Southern Nuclear

# Vogtle Pre-Submittal Meeting (Part 2) to Revise Technical Specification 3.7.2, Main Steam Isolation Valves

August 2021

# Proposed Design

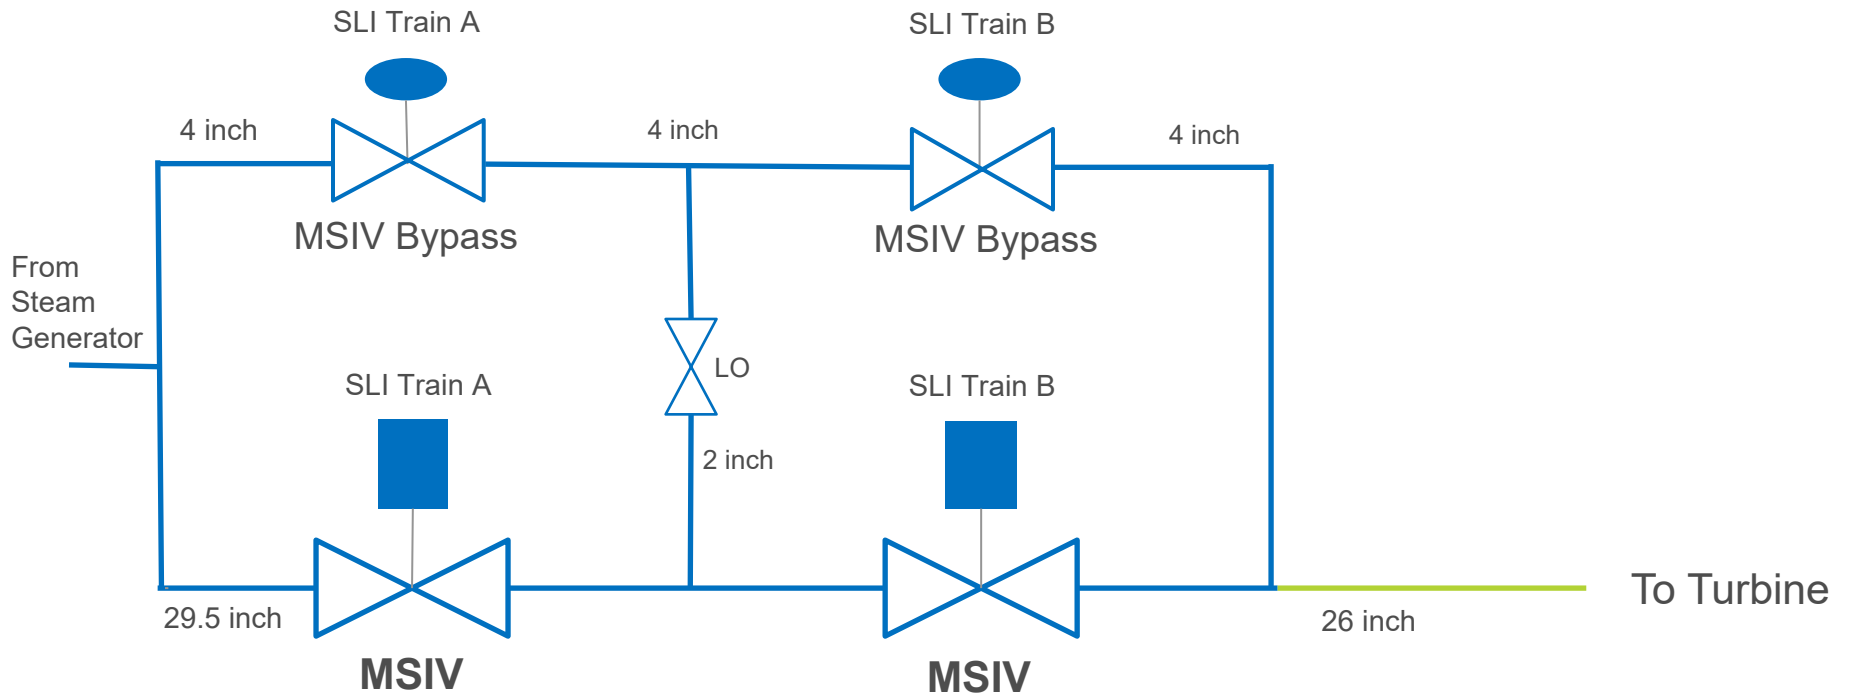
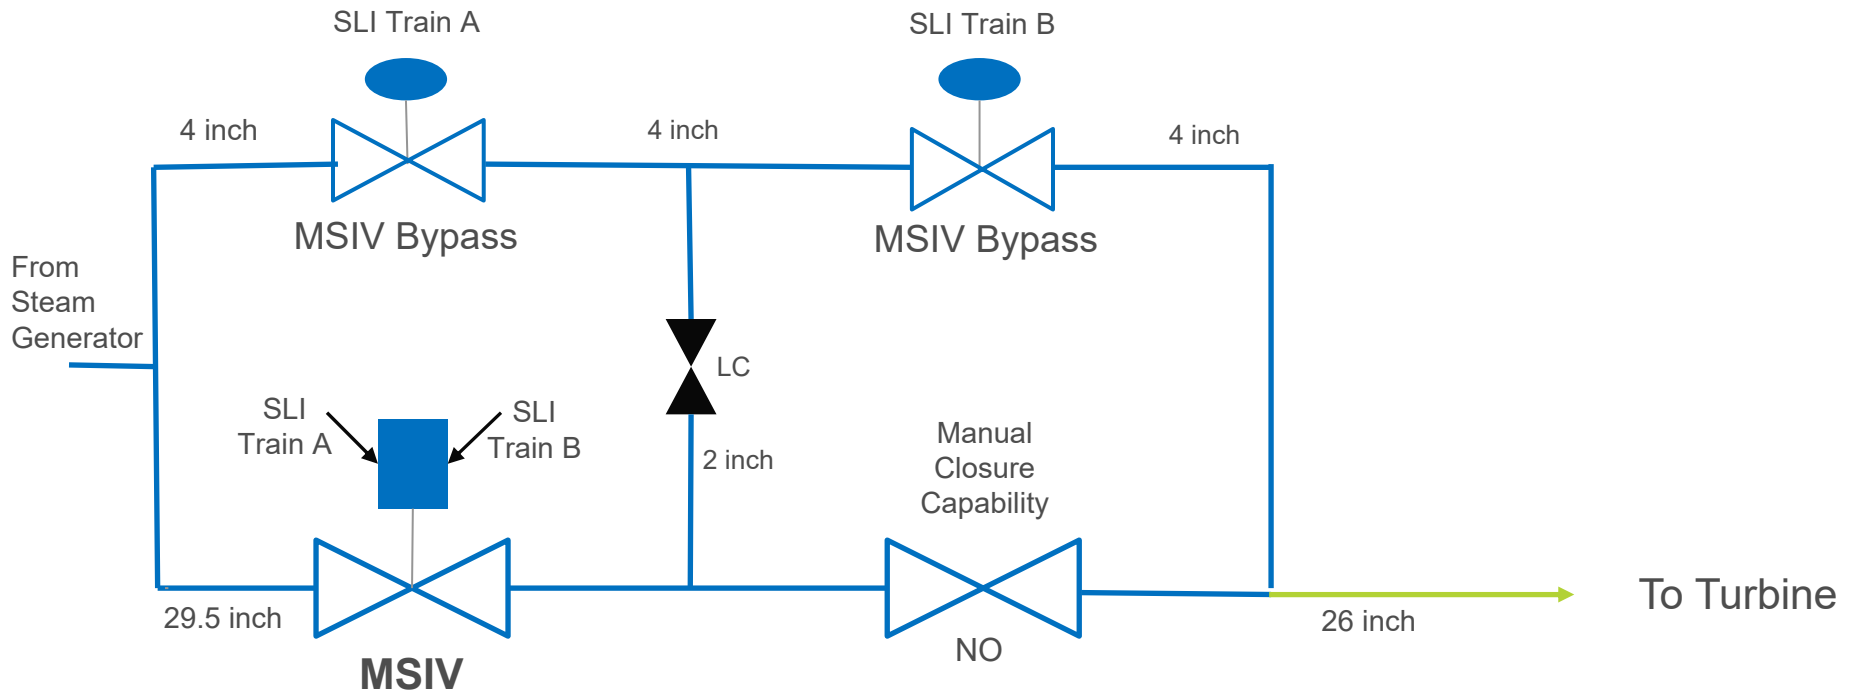
Change the licensing basis and design from 2 MSIV systems per steam line to 1 MSIV system per steam line

- Retain the existing inboard MSIVs – one per steam line
  - Bidirectional gate valve
- Eliminate existing outboard MSIV function
  - Retain outboard valve with capability for manual closure
  - Outboard valve will not receive SLI signal
- Retain both existing MSIV bypass valves
- Change actuation of MSIV closure to include both actuation trains on each inboard MSIV
  - MSIV bypass actuation does not change, as both valves remain in the steam line

Figure 8. Keep Open Schematic

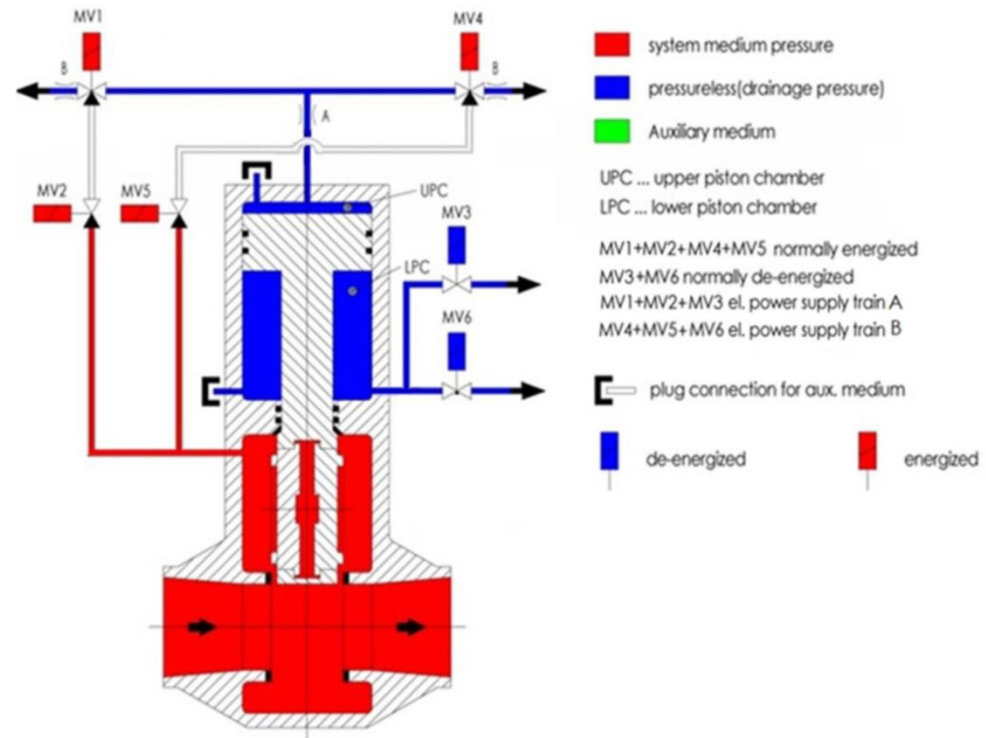
- System Media Actuated
- Dual Solenoid
- Train Separated

- No single active component failure will result in the failure of more than one main steam isolation valve to operate
- MSIV actuator closes valve assuming a single failure
  - Dual paths to supply steam for closure
- Train A and B closure signal to actuator
  - As with current design, signals are generated from separate instrumentation and powered by separate instrumentation control systems
- New design provides safety function assuming single active failure
  - New design credits operation of turbine stop valves, turbine bypass valves to limit blowdown to only one steam generator
